TO: John Sponseller
FROM: Carson Byerhof, Planner I
DATE: July 28, 2022
SUBJECT: SP22-041 – Dunkin Donuts
Review Comments 01

**SITE PLAN FOR
DUNKIN' DONUTS
DOUGLAS 234, FILING NO. 6,
AMENDMENT 1, LOT 4**

DRAWING NO. 10
TST SUBMITTAL

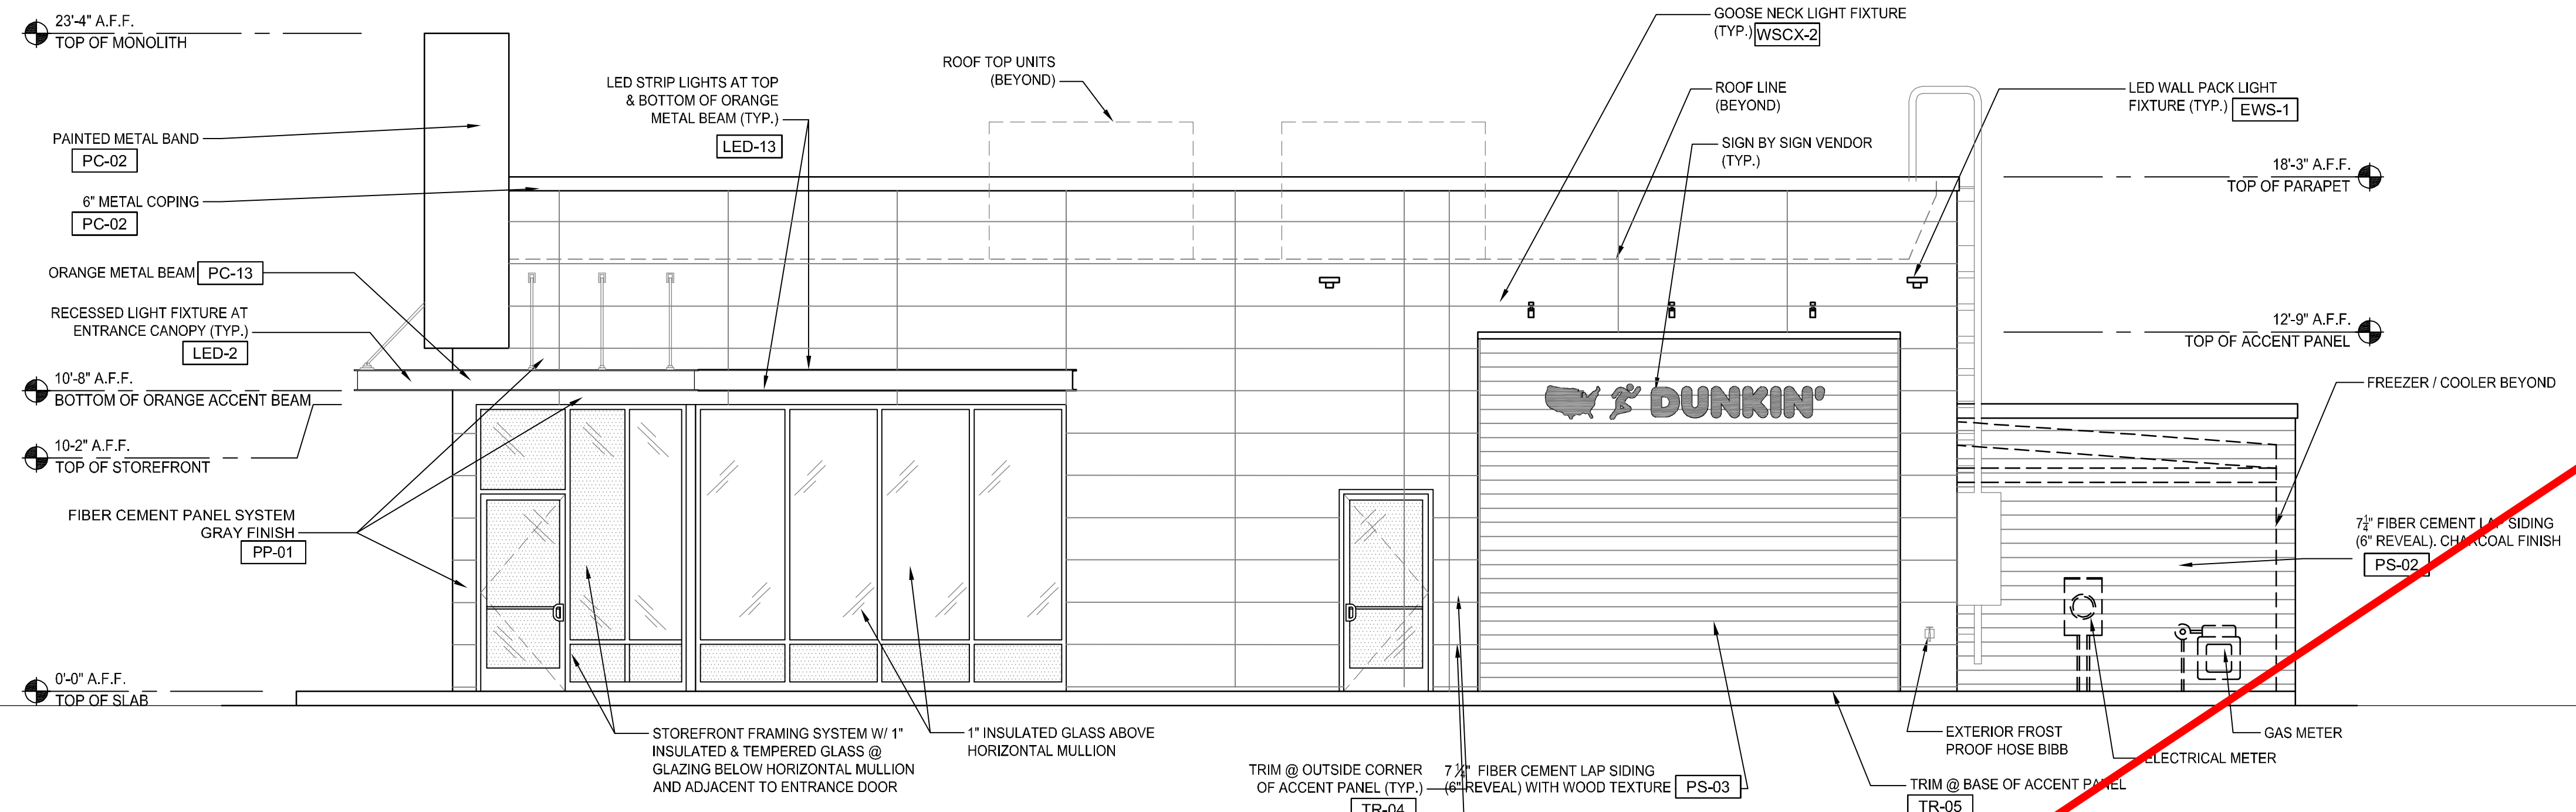
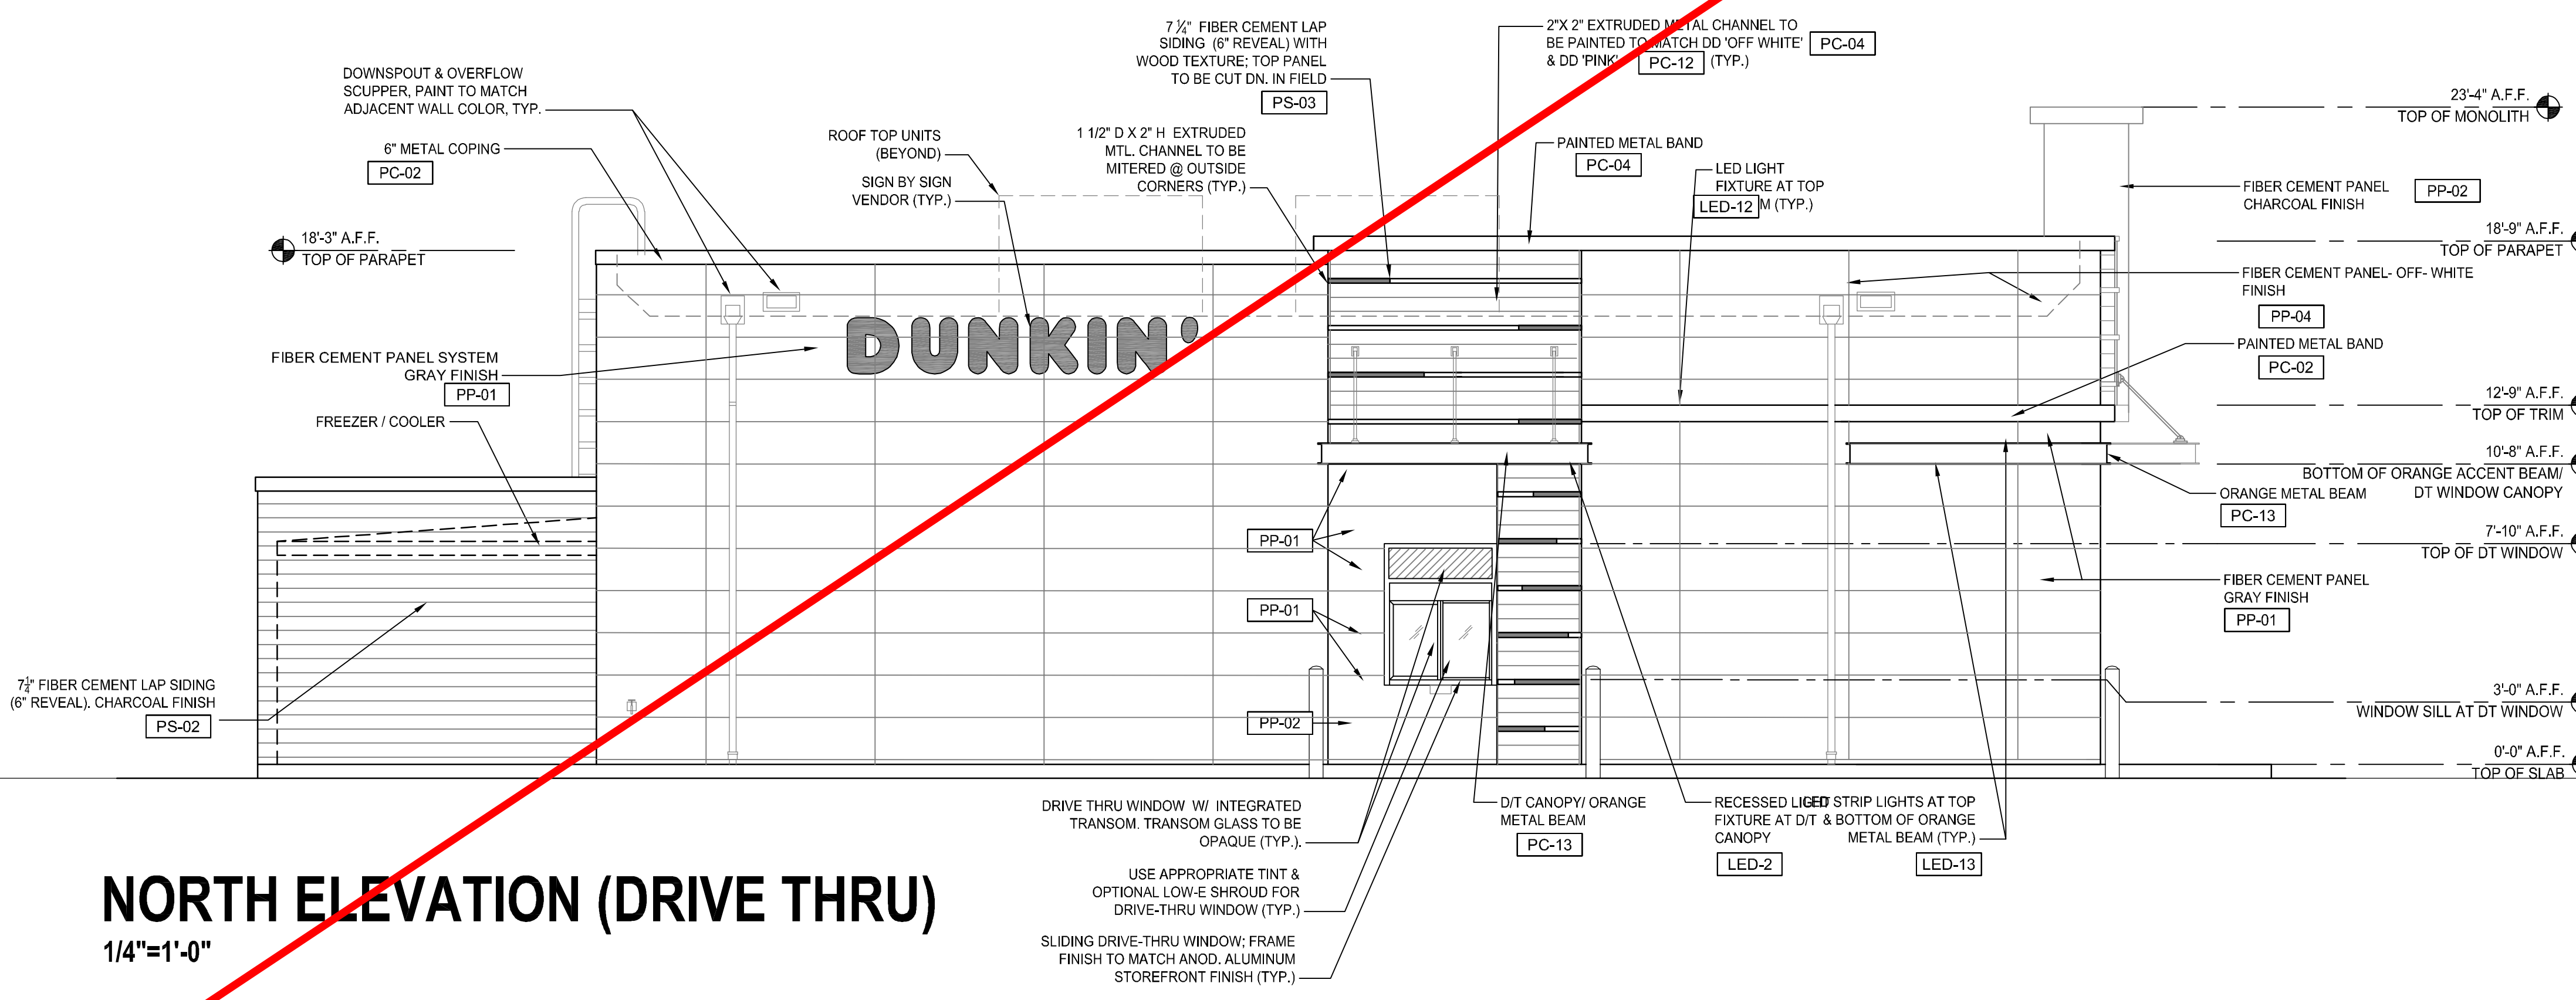
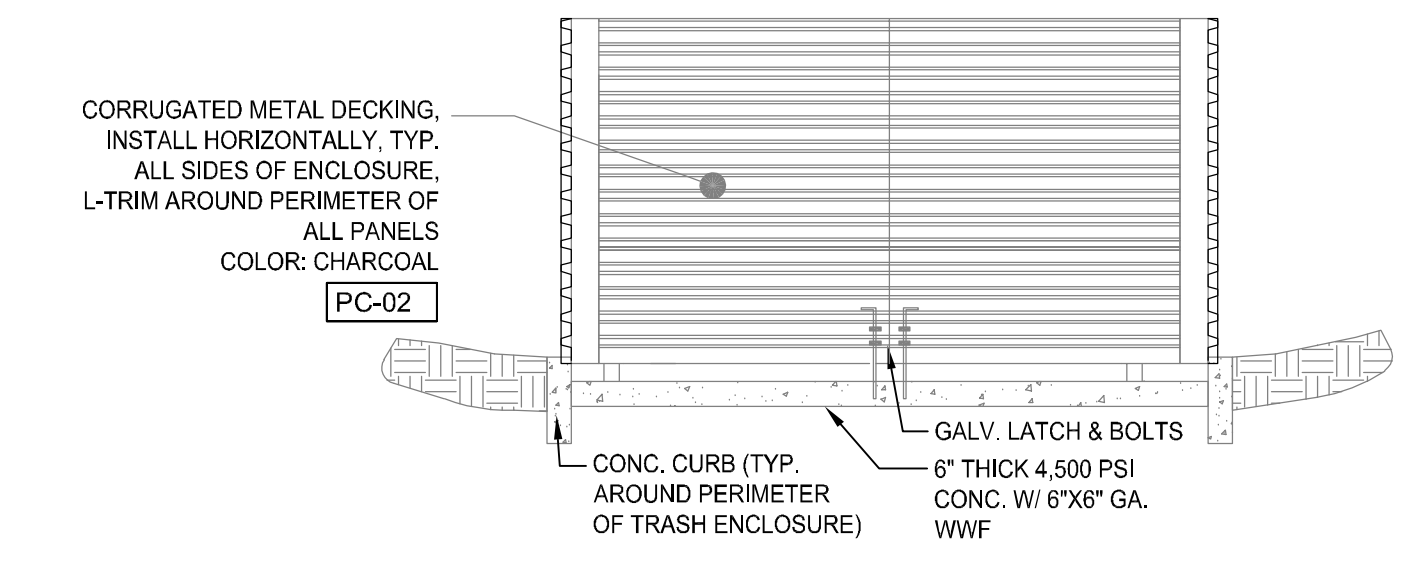
See planning reviews on colored elevations. Include colored elevation with exhibits for next submittal

DRAWING NO. **12**
SHEET NO. OF

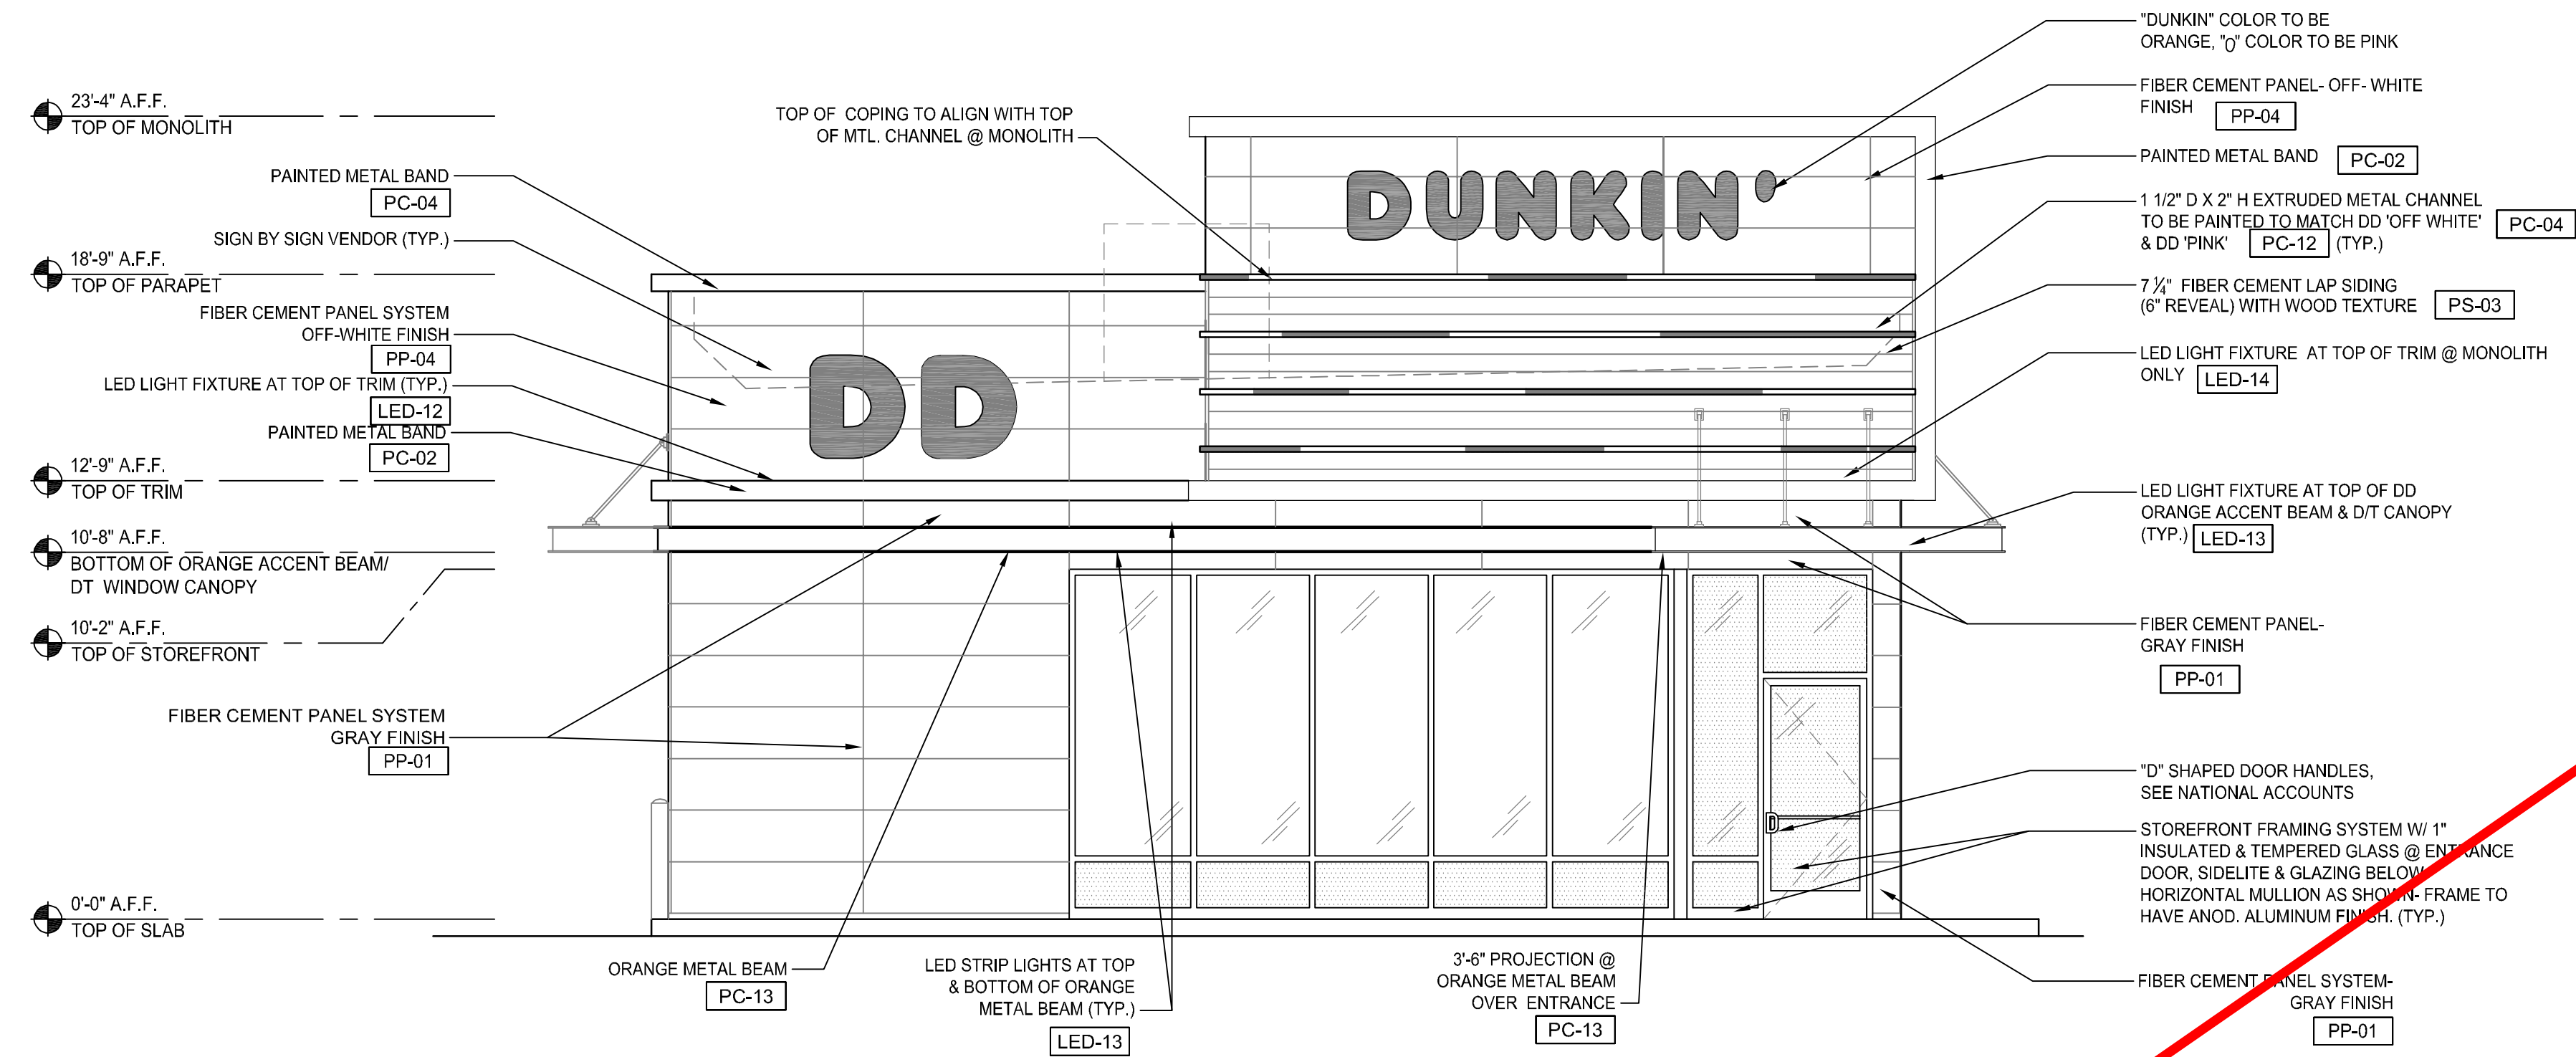
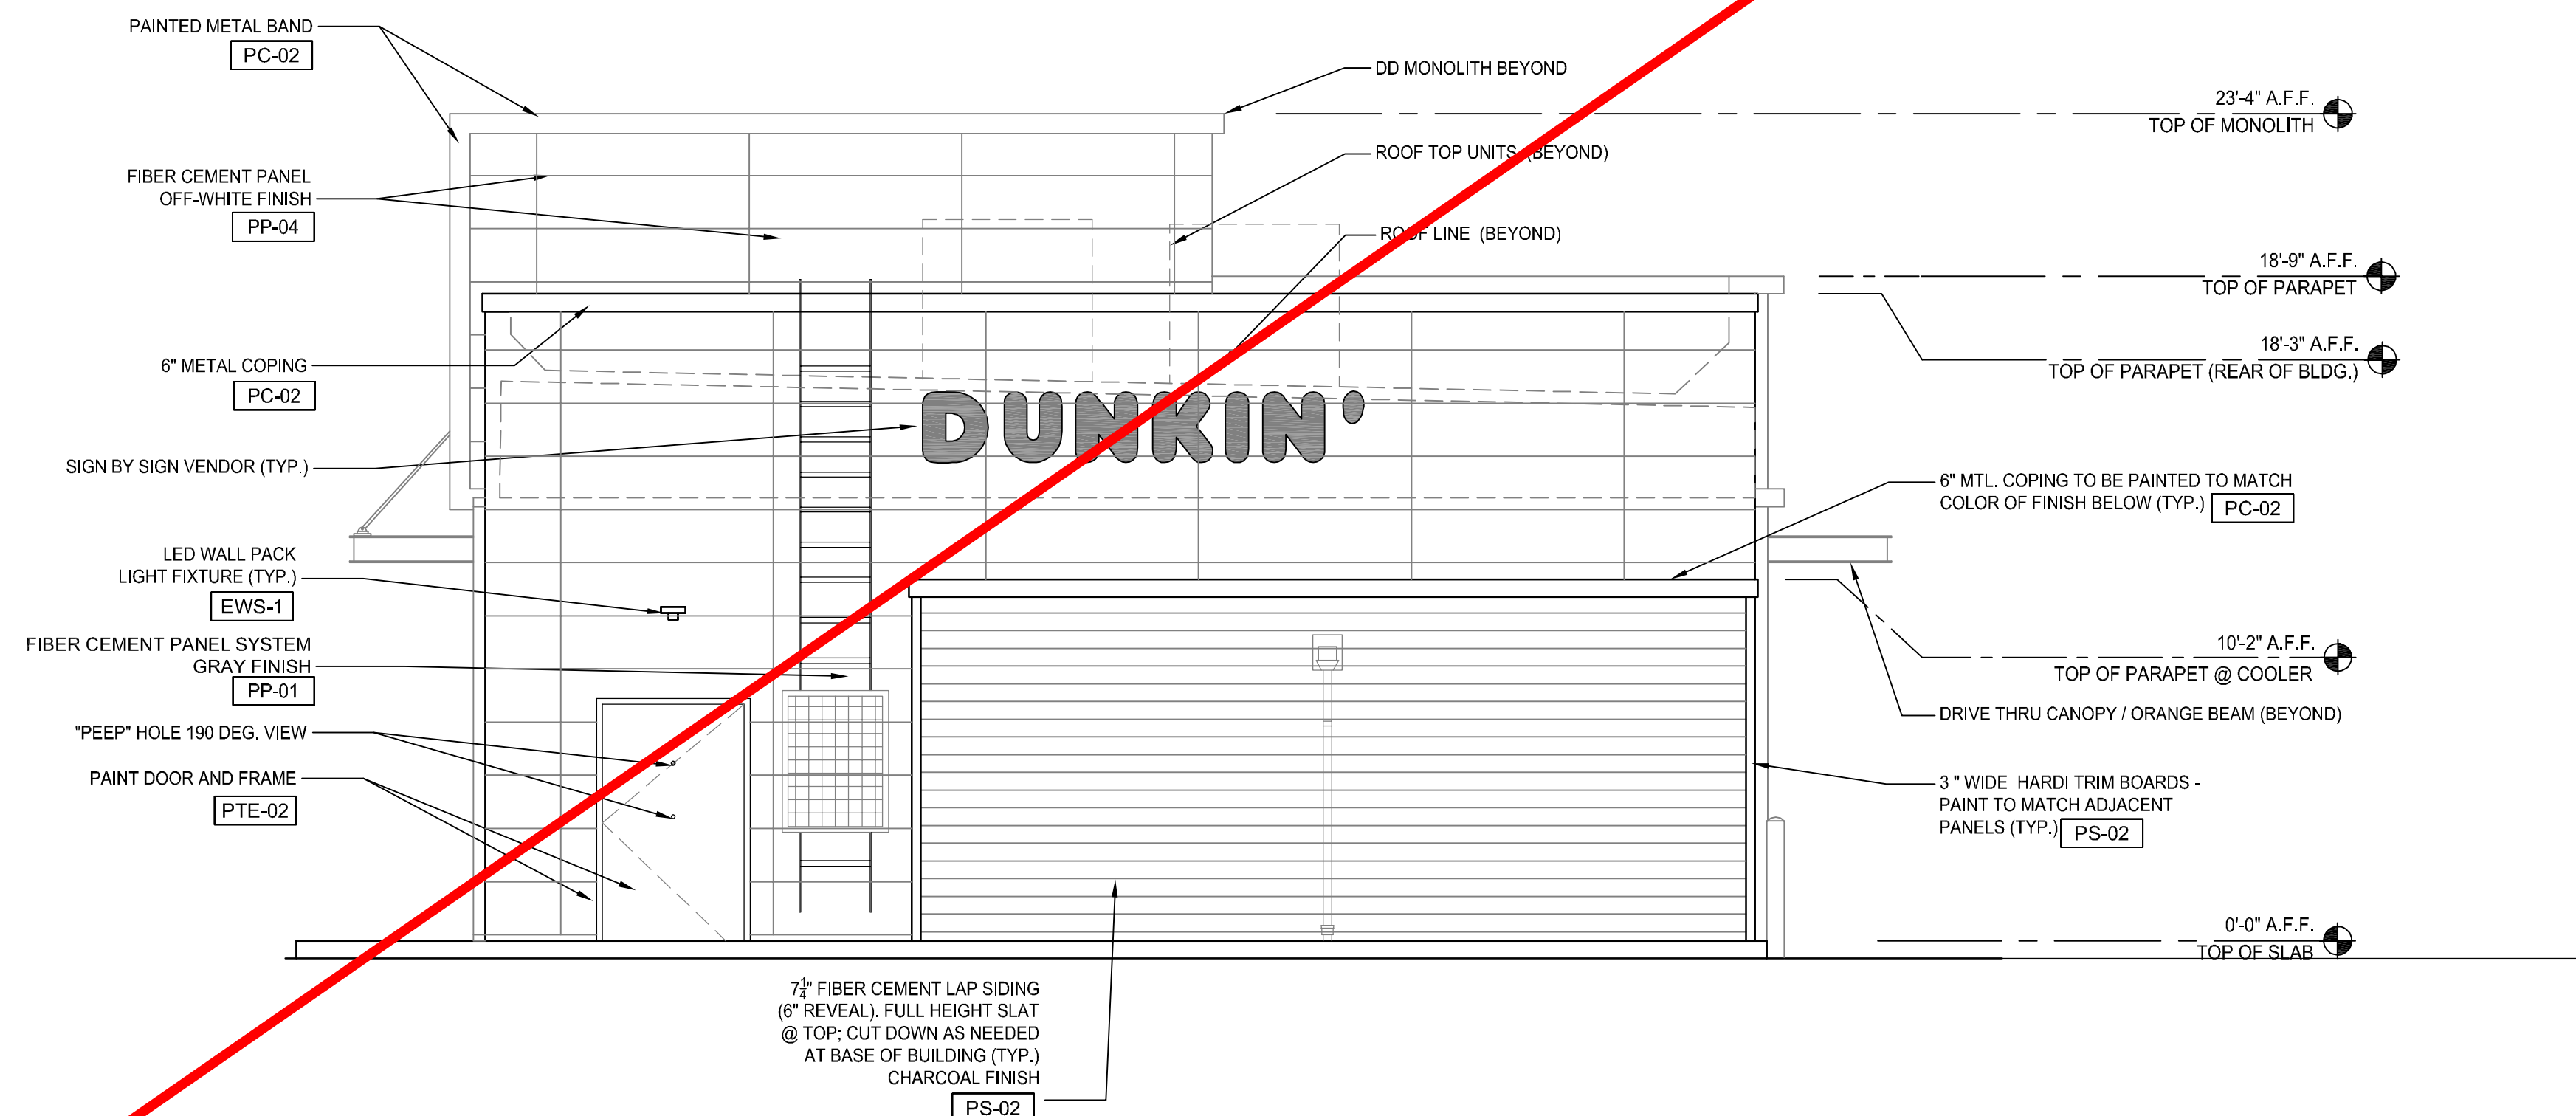
See planning reviews on colored elevations. Include colored elevation with exhibits for next submittal
